URGENT Field Safety Notice

MR systems with 60cm wide bore

Quadrature Body Coil (QBC) seal adhesive failure may result in exposure of sharp edges

28-December-2023

Figure 1. QBC seal location

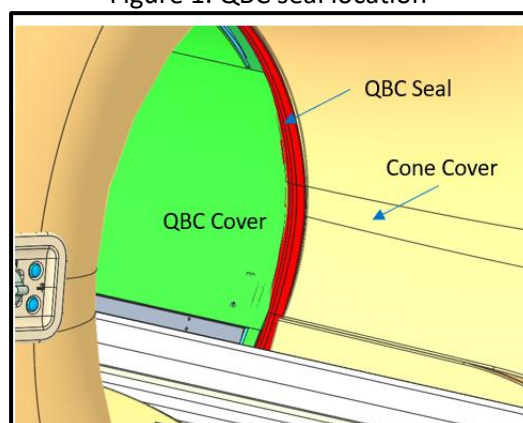
The Quadrature Body Coil (QBC) seal adhesive may fail creating sharp edges that may come in contact with patients. The QBC seal may become loose as the patient table travels in a horizontal motion in and out of the system bore. The QBC seal (Figure 1) is a rubber seal that is glued between the cone cover and QBC cover and functions to prevent sharp edges of the QBC cover from contacting patients during an examination.

If the QBC seal becomes loose during the scanning process, the risk to the patient may include one or more of the following: skin abrasions, bruises, lacerations, hair loss/entanglement, and tissue injury.

- As part of the preparation before a patient scan:
 1. Inspect the QBC seal for separation between the cone cover and QBC cover.
 2. If QBC seal is found detached or loose, **Stop-use immediately**.
 3. Contact your local Philips service representative.
- If QBC seal becomes loose during a patient scan:
 1. **Immediately stop scanning** and carefully remove patient from the system.
 2. Contact your local Philips service representative.

Philips will contact you to schedule a time for a Field Service Engineer (FSE) to visit your site and replace your system's QBC Seal (reference FCO78100573). Philips plans to start implementing corrections in Q3 2024.
